ECN/PCN No.: M1701

<b>Product Description:</b>  Series-Connected Supercapacitor Module, 6.0V	<b>Abracon Part Number / Part Series:</b>  ADCM-S06R0S	<input type="checkbox"/> Documentation only <input checked="" type="checkbox"/> ECN <input type="checkbox"/> EOL	<input type="checkbox"/> Series <input checked="" type="checkbox"/> Part Number(s)
<b>Affected Revision:</b> B	<b>New Revision:</b> C	<b>Application:</b> <input type="checkbox"/> Safety <input checked="" type="checkbox"/> Non-Safety

Prior to Change:

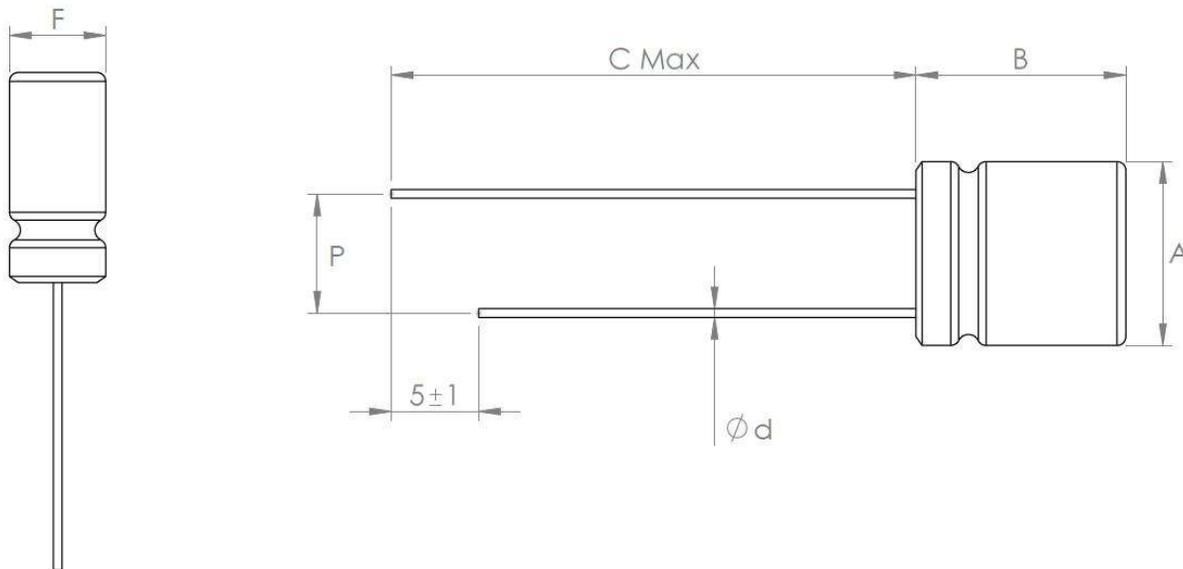
Mechanicals dimensions have changed slightly to smaller A x F x B size. Pin pitch has increased by 0.5mm center-on-center.
